**Item 3.****Development Application: 545-549 South Dowling Street, Surry Hills - D/2023/403**

File No.: D/2023/403

**Summary**

**Figure 29:** Tree Location Plan

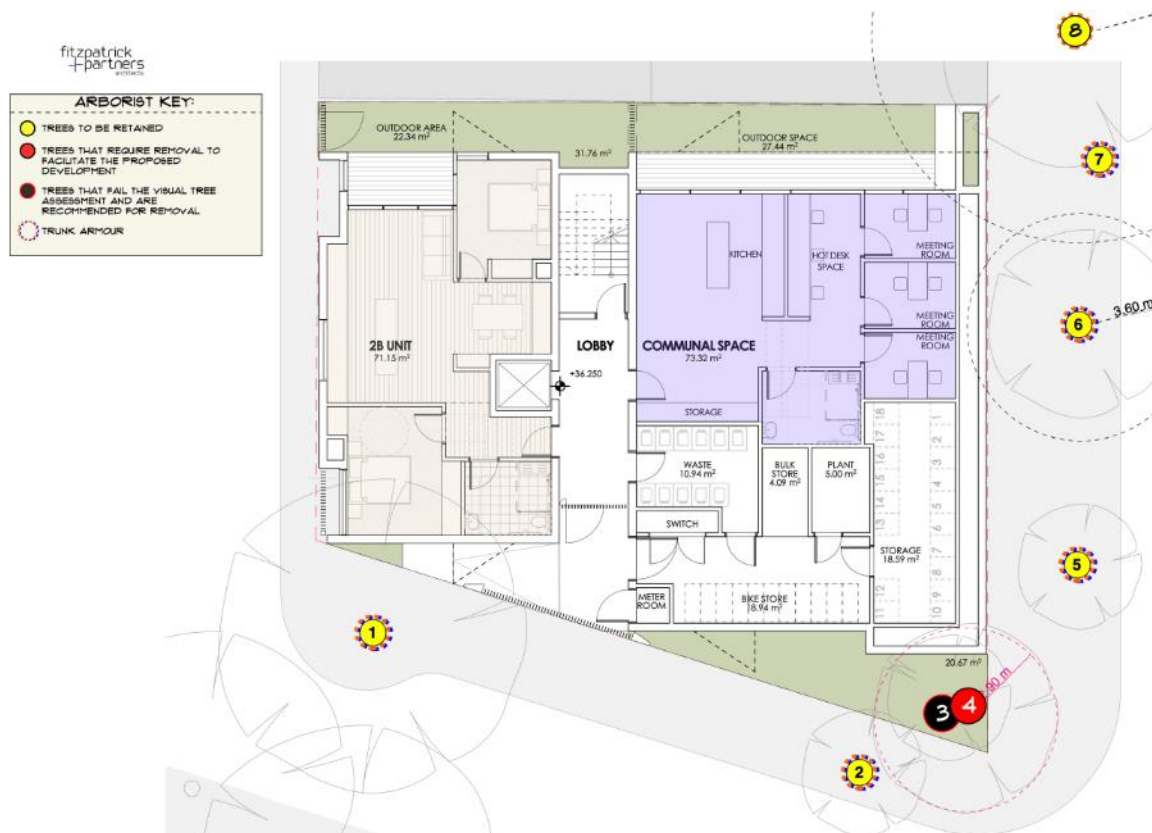
- **Council Comment:** Council's tree management officers requested further clarification regarding the impact of the proposal on the retention of street tree 1 and 2 located on Phelps Street.

**Response:** An amended Arborist Statement has been provided with additional information on the impact of the proposal on trees 1 and 2.

**Figure 57:** 3pm Solar Impact to neighbouring windows on Phelps Street

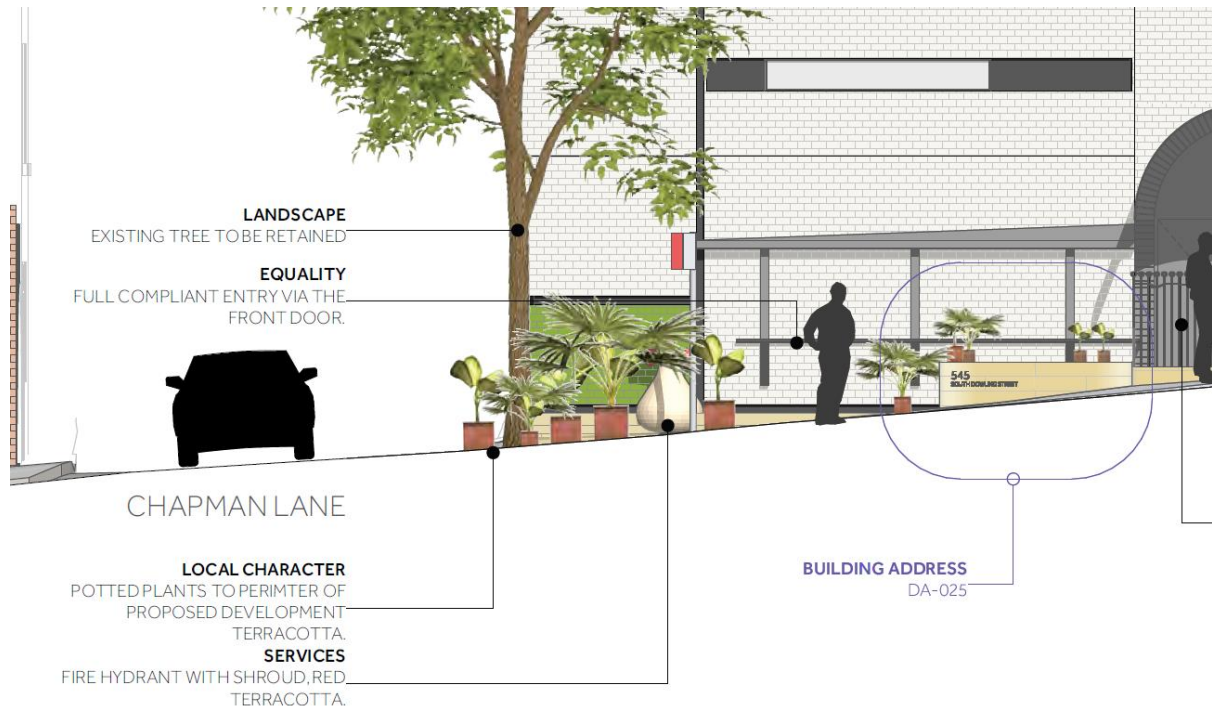
109. The proposed location of the fire hydrant booster in the pot plants on Phelps Street as illustrated in Figure 57 below is not supported. As discussed in the 'Amendments' section above, it was recommended that services be neatly integrated into building rather than into planting as proposed. A condition of consent is recommended in the notice of determination requiring the amendment of the proposal to integrate the fire hydrant booster into the building fabric.

Figure 58: Section Plan - Sightlines

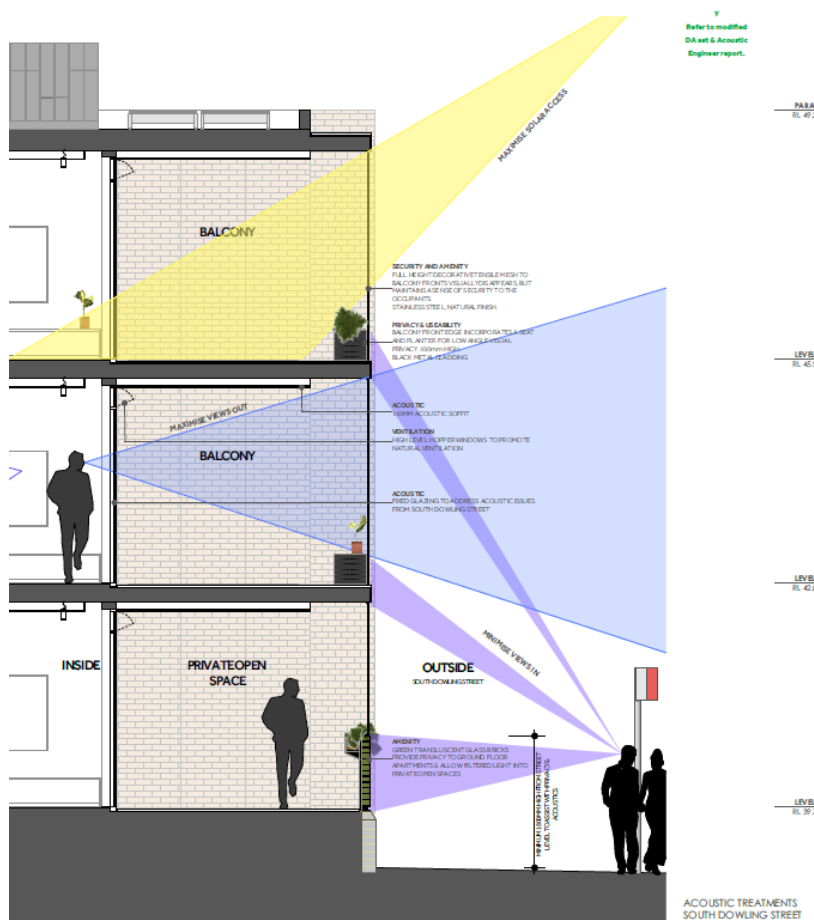
- **Comment:** The proposal should be amended to include privacy screens to prevent residents seeing externally into the private open space of neighbouring properties

**Response:** The proposed balconies incorporate a 450mm planter and seat to the front edge of the floor to ceiling mesh screen to ensure low angle visual privacy form the street.
